Public Consultation
Submission Report –
Second & Third Non-
Statutory Public
Consultation

Kimmage to City Centre Core Bus Corridor

Preferred Route Option

Second and Third Public Consultation Submissions Summary Report

Section 2 – Sundrive Cross to Harold’s Cross Park

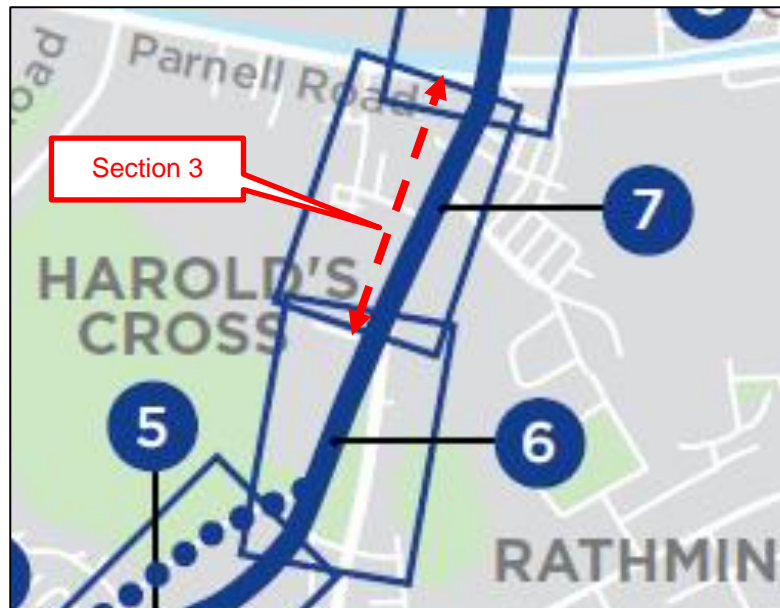
Main comments noted:

Pedestrian and Cycling facilities:

- Cycle lanes on Kimmage Road Lower.
- Proposed new pedestrian and cycle route at the Stone Boat Boardwalk linking Sundrive Road to Mount Argus.
- Traffic speed on Kimmage Road Lower and safety for pedestrians and cyclists.

Section 3 – Harold’s Cross Park to Grand Canal

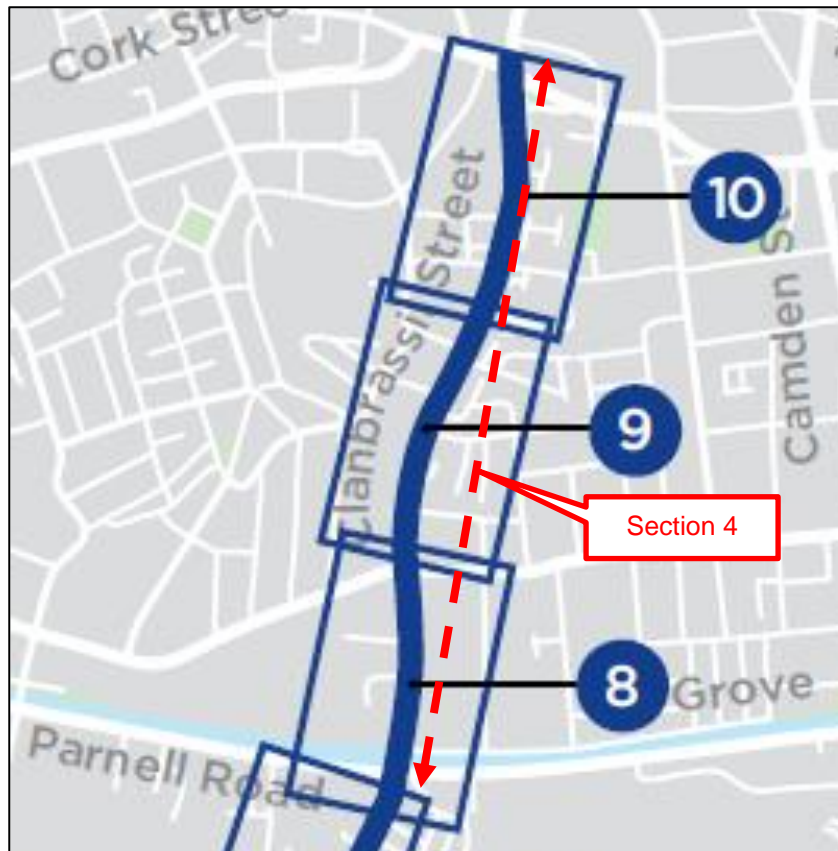
Main comments noted:

Pedestrian and Cycling facilities:

- Cycle tracks on Harold’s Cross Road rather than cycle route via Greenmount Lane.
